BNSF Energy Management  
Human Factors Evaluation  
PTC CDU Integrated Screen Configuration

Final Report

April 14, 2016

**HEURISTIC EVALUATION & COGNITIVE WALKTHROUGH**

FIGURE 1: YELLOW EM OVERLAY MESSAGES

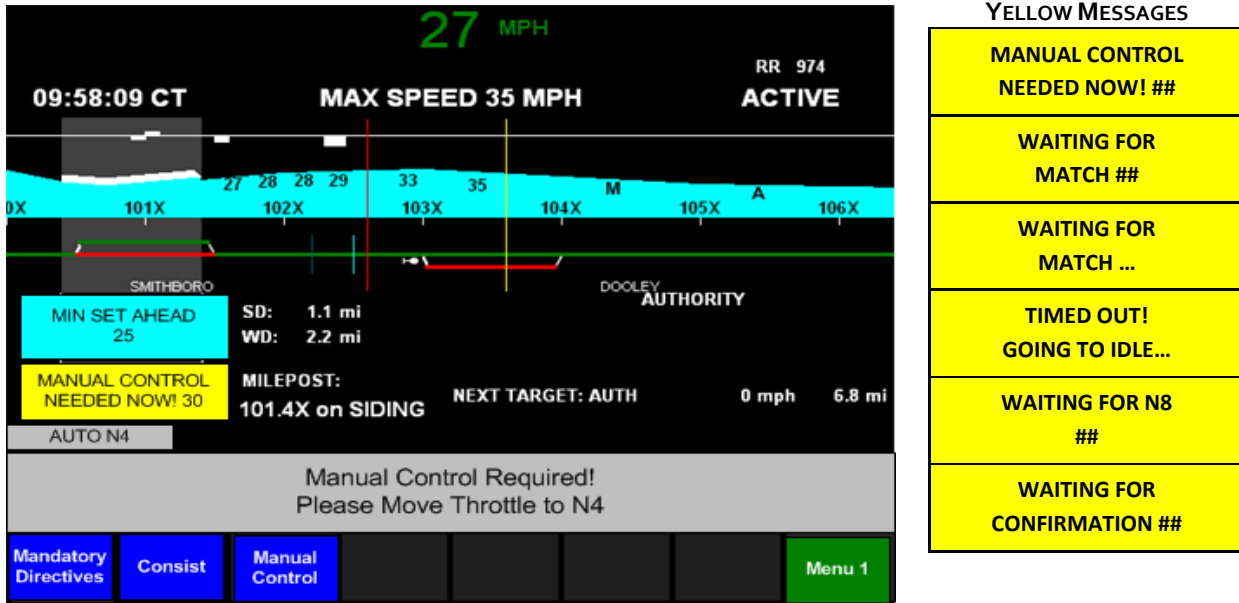
In practice, from a review of the messages provided, yellow is used when actions are required on the part of the crew to transition between Manual and Auto Control modes. See Figure 1: Yellow EM Overlay Messages for a list of EM messages presented with a yellow background and an example of the yellow message area in use.

The PTC system has clearly established the use of yellow outside of the Track Line Map to indicate required actions that are related to safety and that, if not taken, will result in a Penalty Brake Application. Yellow PTC banners indicate that the system will apply a penalty brake within the time indicated. The only escalation beyond this graphical element, which is signified by a red banner, results in a penalty brake application.

FIGURE 3: YELLOW EM OVERLAY MESSAGES

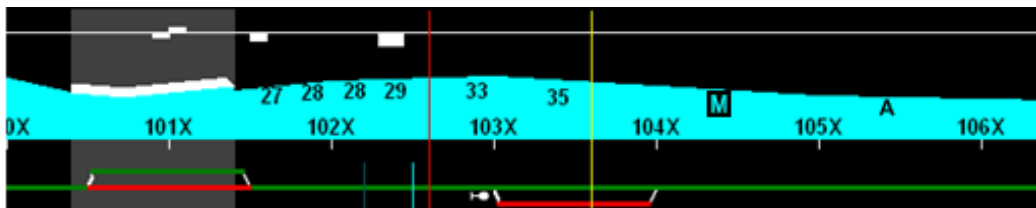
In the AAR implementation, upcoming Manual Control Zones are depicted with gray backgrounds on the Rolling Map, which is very salient. In this implementation, the corresponding indication is an M placed in line with the Plan Speeds. The saliency of this element is very low. While the Overlay Message Boxes will also alert the user to upcoming manual control zones, consider increasing the saliency of this indicator, such as presenting it in a different color, or increasing the size of the font, or presenting a border around the M.

Note that this issue ties in with the issues discussed in 4.3.1 Visual Density Associated with Plan Speeds. Alternative implementation examples are presented in Figure 6: Proposed Changes for EM Plan Speeds that are in line with the recommendations to resolve the issue discussed in that section. The image depicted below represents an alternative implementation of the existing design.

It should be noted that plan speeds have the capability of flashing, which is not currently utilized by BNSF. This is a circumstance under which flashing the plan speed would be acceptable from a human factors perspective, if no other acceptable alternative can be implemented.

FIGURE 4: WELCOME SCREEN

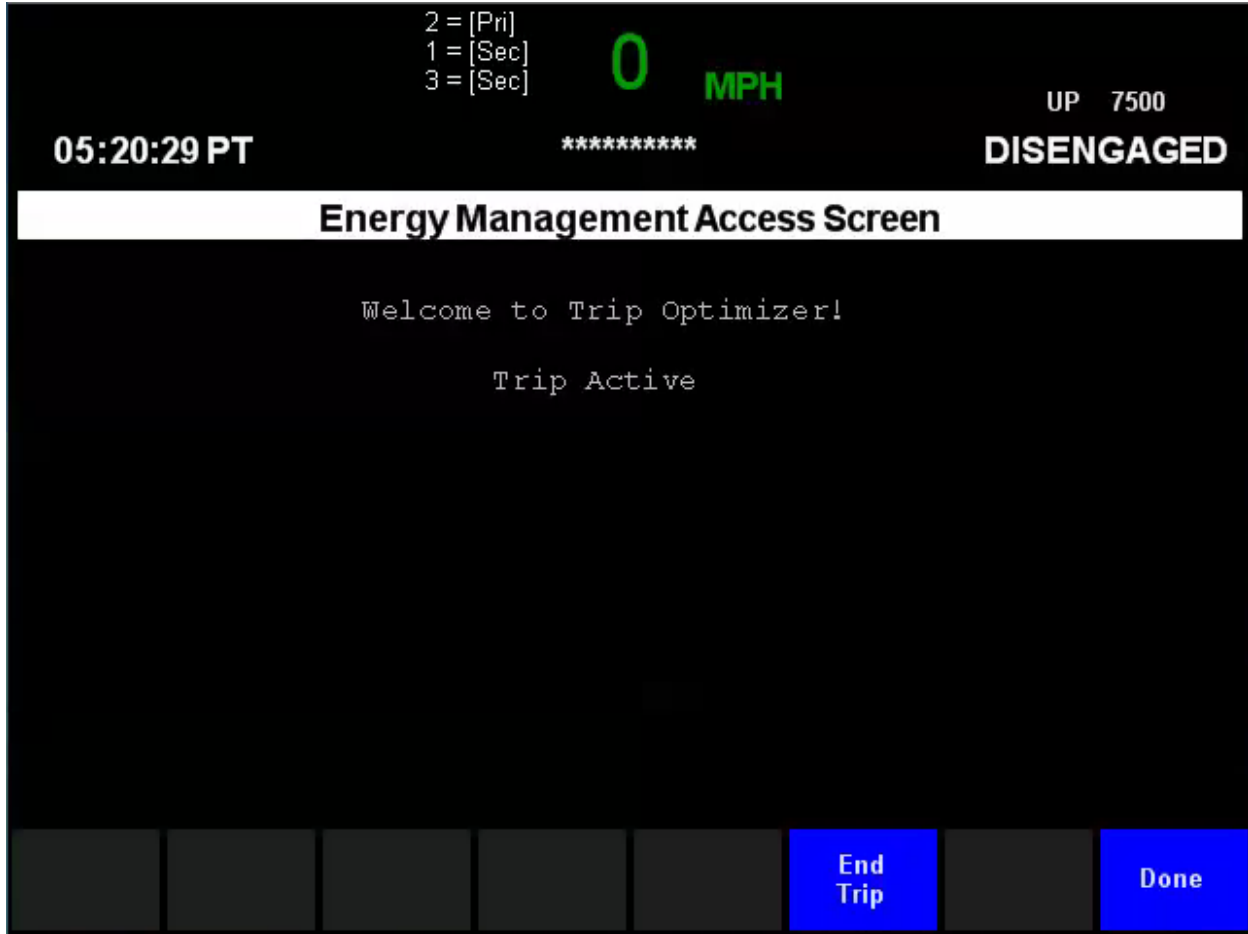
The Welcome screen below is presented after the engineer accepts a trip, to confirm that TO and the trip are active. However, this screen provides no real value to the user aside from confirming that TO and the trip have been initiated and providing a means to end the trip. Further, though it is assumed that any message from PTC would cause this screen to be removed, this screen still competes with PTC for display time.

Eliminate this screen and move the confirmation message to a banner message or present it via the recommended persistent TO indicator (see 4.3.2 Lack of Explicit EM Active Indication). The means to end the trip should be moved to another screen or implemented as a button press directly accessible from the PTC menu.

FIGURE 5: EM PLAN SPEEDS DISPLAY

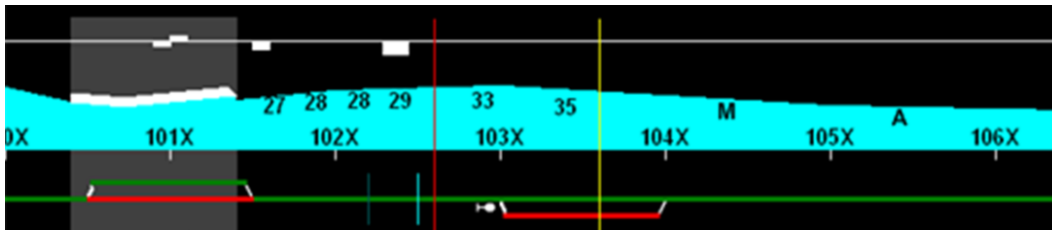
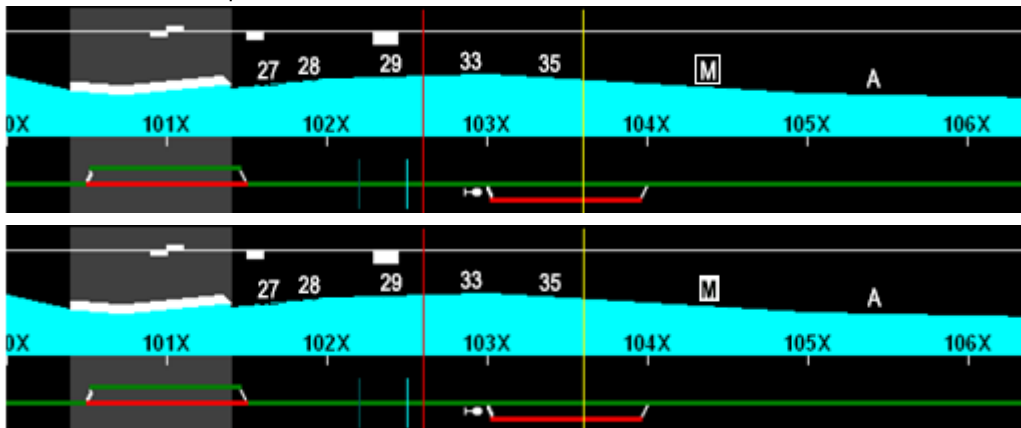
As implemented, the plan speeds 1) increase the visual density of this part of the interface, particularly when the plan speeds include redundant speeds; and 2) are hard to differentiate from the mileposts because they are tightly spaced with the mileposts and use the same font type and color as mileposts.

Consider also restricting plan speed indicators to only those that add unique value. The above example fails to meet this criterion, as a second value of 28 immediately follows the first 28, providing no unique value.

Redesign the display to further separate Plan Speeds from mileposts.

Eliminate redundant Plan Speeds.

If possible, consider placing the plan speeds above the track elevation so that the train appears to be “driving through” the plan speed. This dramatically reduces the visual clutter and visually ties the plan speed to the train’s forward movement.

Note that the use of white for the plan speeds in the above depiction further contributes to the visual association of the train and the plan train speeds, and the depiction of the Manual Control Zone indicator is in line with recommendations from section 4.2.2 Low Saliency of Upcoming Manual Control Zone.

FIGURE 7: EM ADVISORY TEXT BANNER

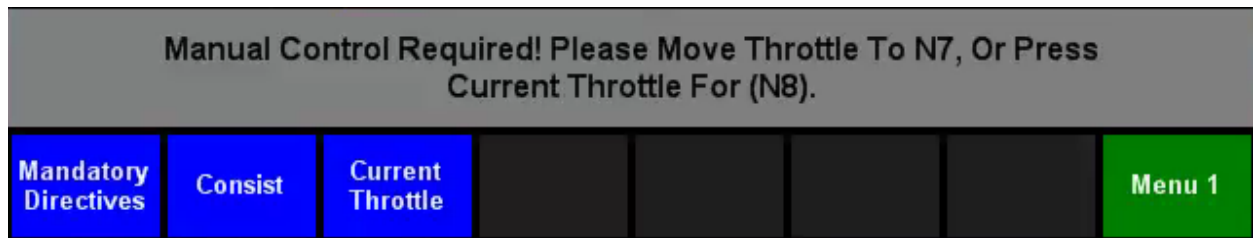
However, there are several issues with the way that text is presented within the banner.

FIGURE 8: FEATURES ACCEPTANCE SCREEN

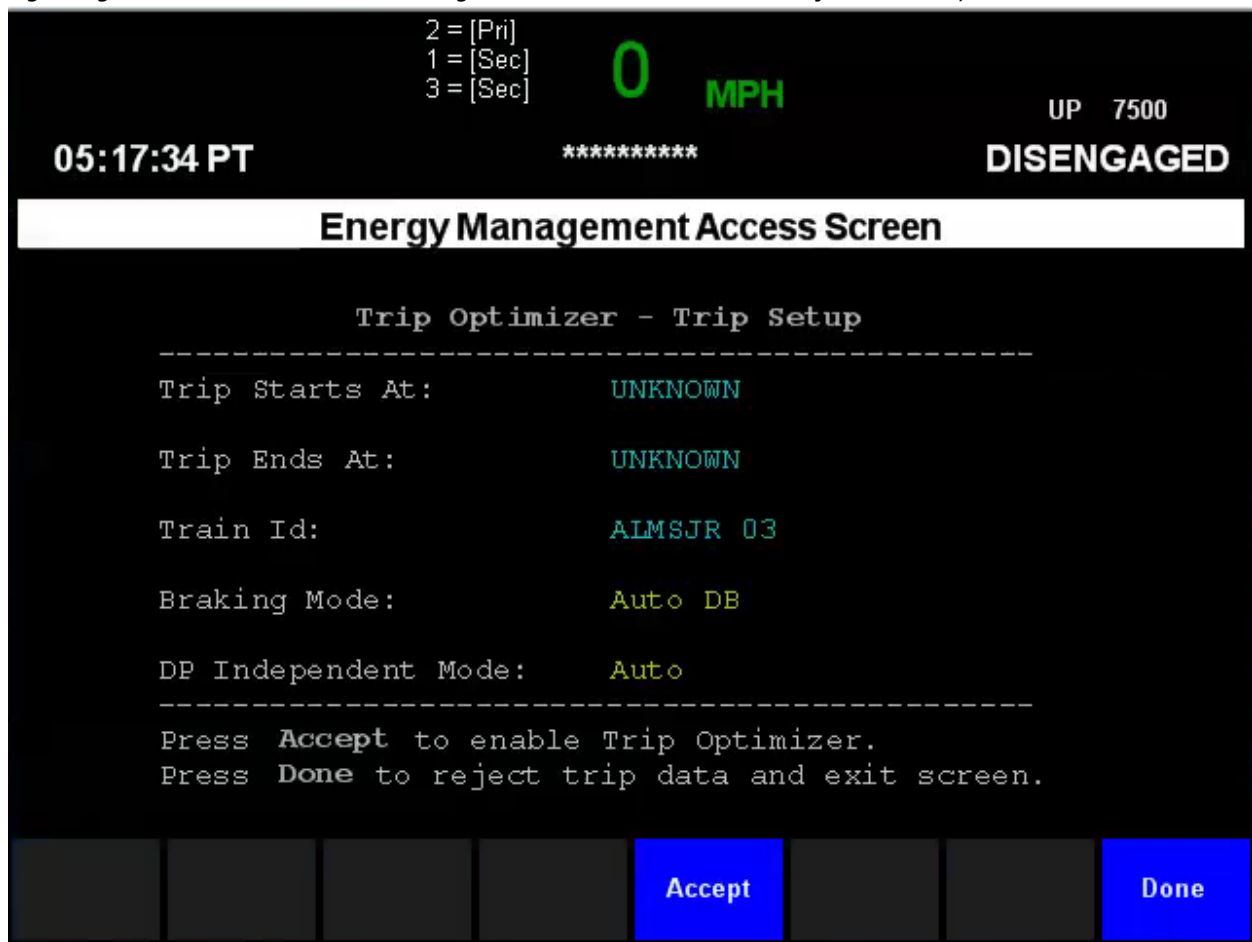
In the features acceptance screen, the engineer may accept the trip information and enable TO or may reject the trip and exit TO. However, the button to reject the trip is "Done". Though instructions are present on the screen, regarding this button, "Done" is too ambiguous. This button should be "Reject" to clarify its action.

All button labels should be evaluated for clarity of action.

FIGURE 1: AAR STYLE CONTROL STAND, C4 & ES44AC/DC AAR DISPLAY – VIEWING ANGLE

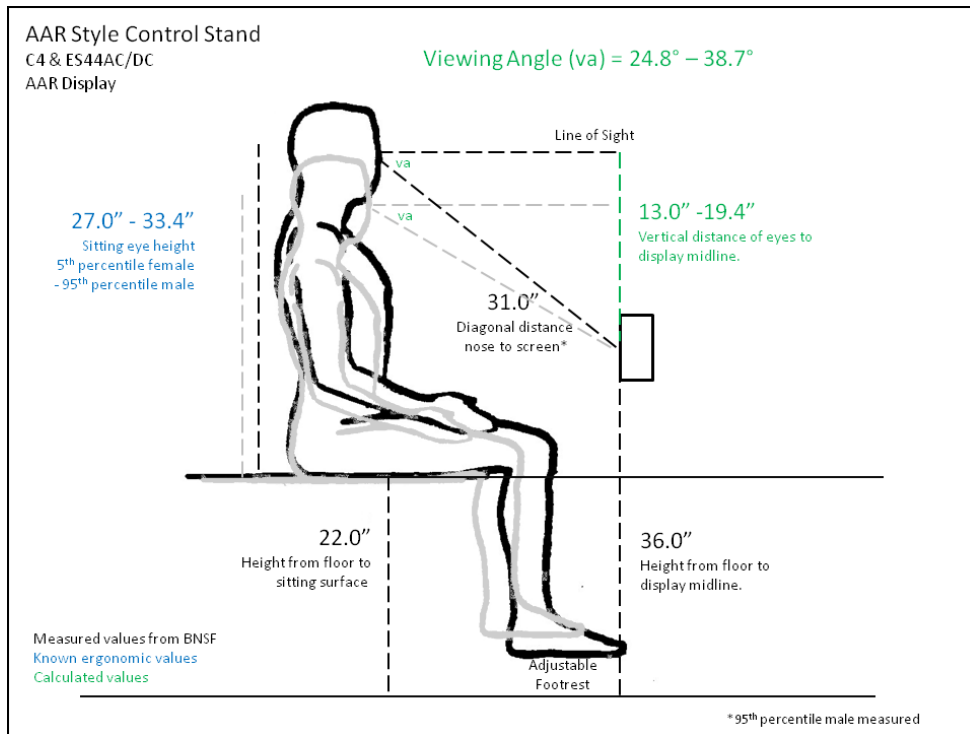
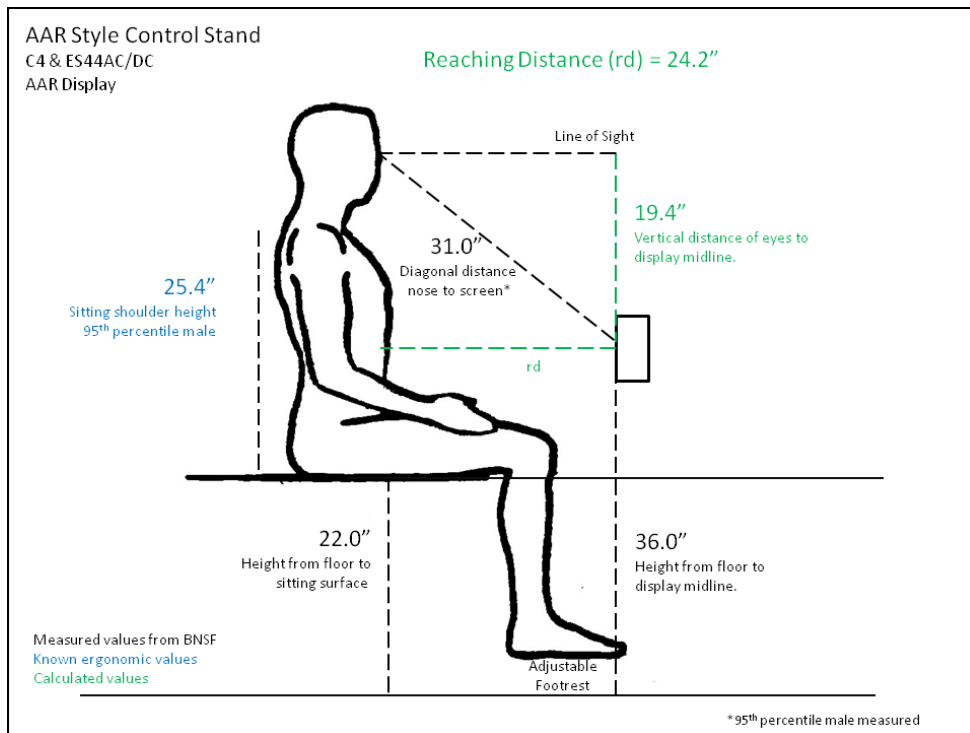
For the AAR implementation of EM, from an ergonomic perspective, the position of the AAR screens is ideal in terms of viewing the displays. They are well within the field of view of the operator and are in the line of sight out the front windshield without obstructing the view out the windshield or of other equipment.

The push buttons to respond to and control the EM features on the AAR screens exceed the normal reach envelope, but reside within the extended reach envelope and are well below shoulder height for even small operators. Given that physical interactions with the AAR screens, as related to EM, will be infrequent while the train is in motion, this is acceptable.

FIGURE 1: AAR STYLE CONTROL STAND, C4 CDU DISPLAY - VIEWING ANGLE

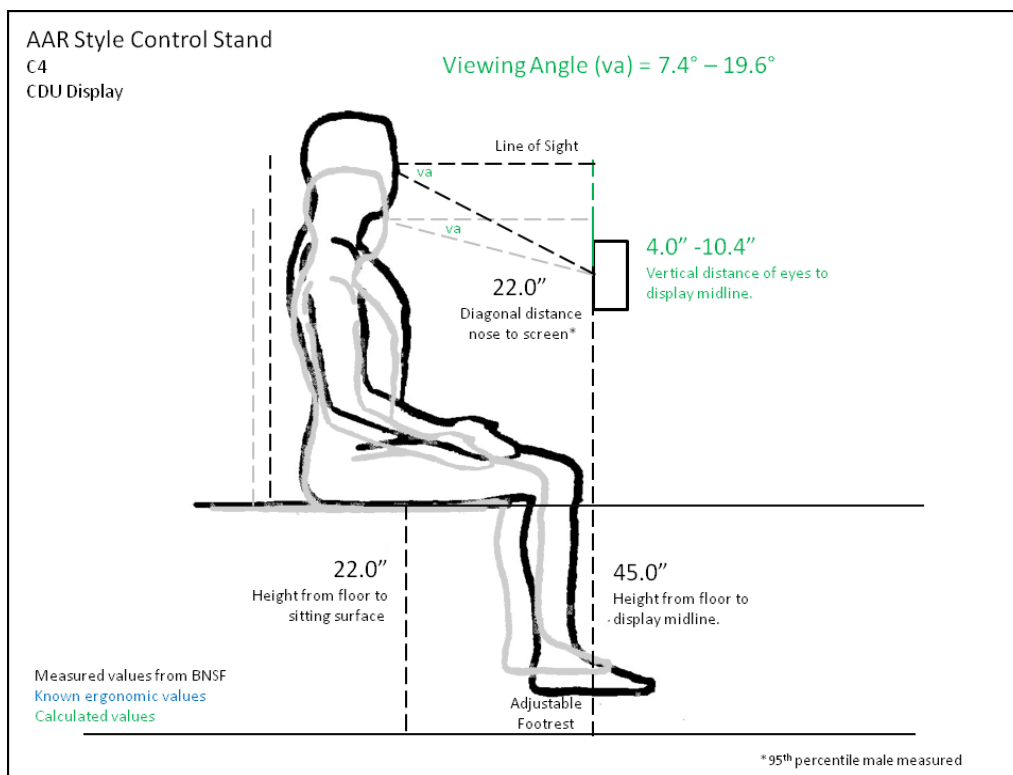
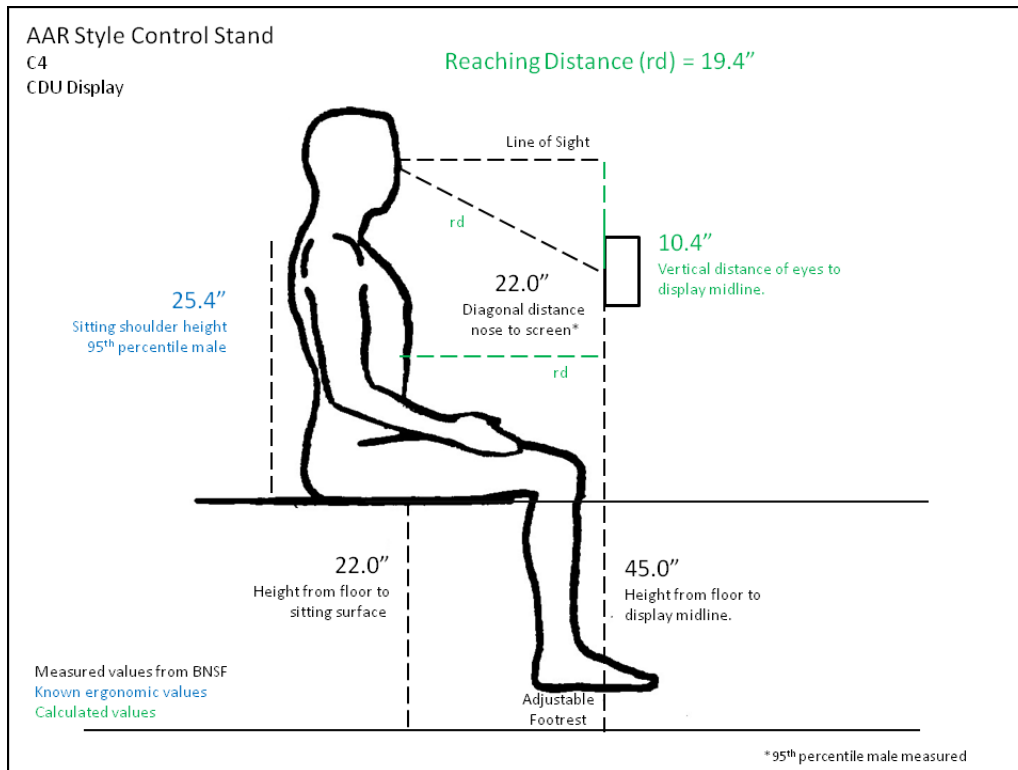
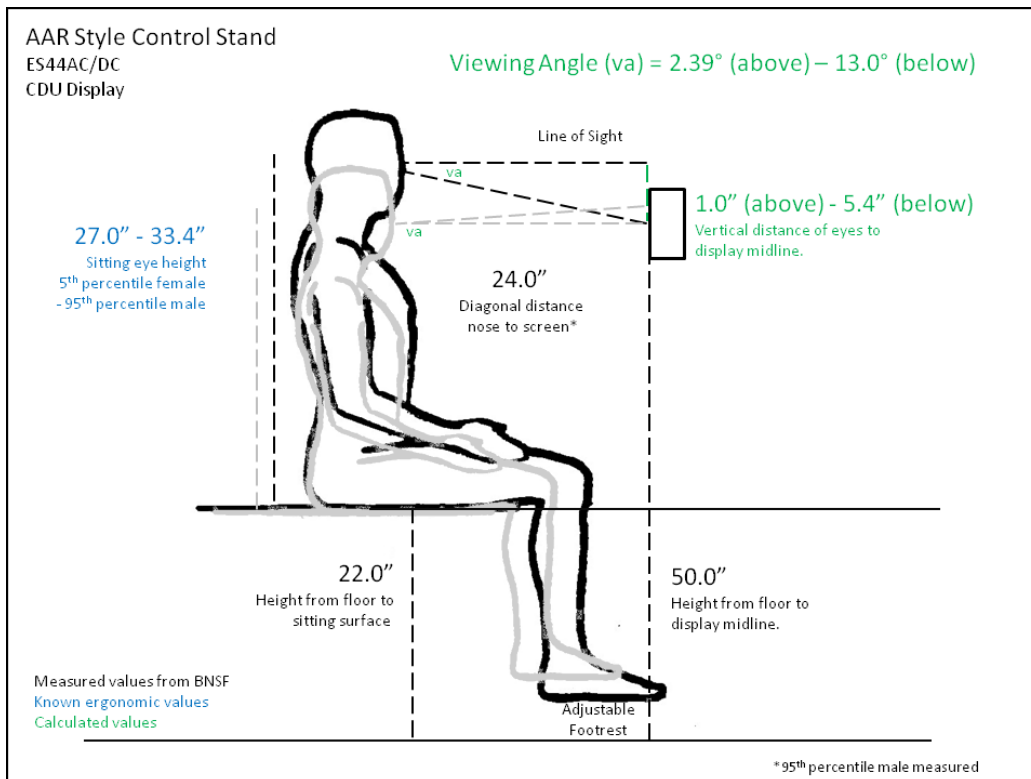
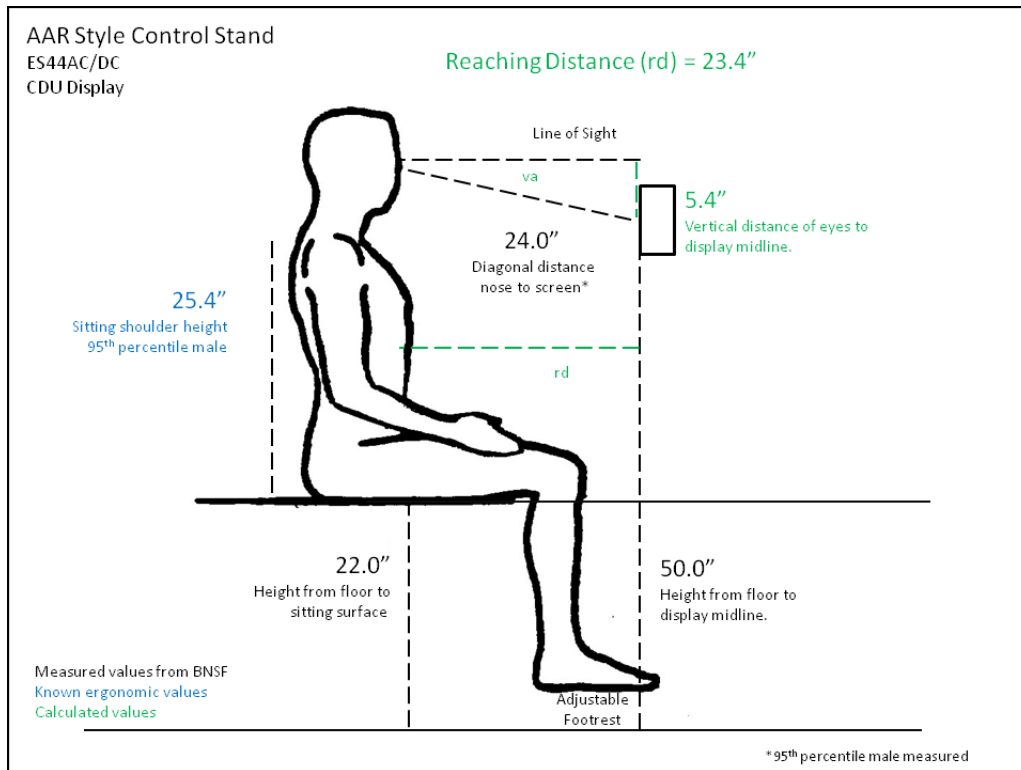
For implementation in which the EM is integrated into the PTC display, the CDU location is less than ideal, given its position to the side of the operator (discussed below).
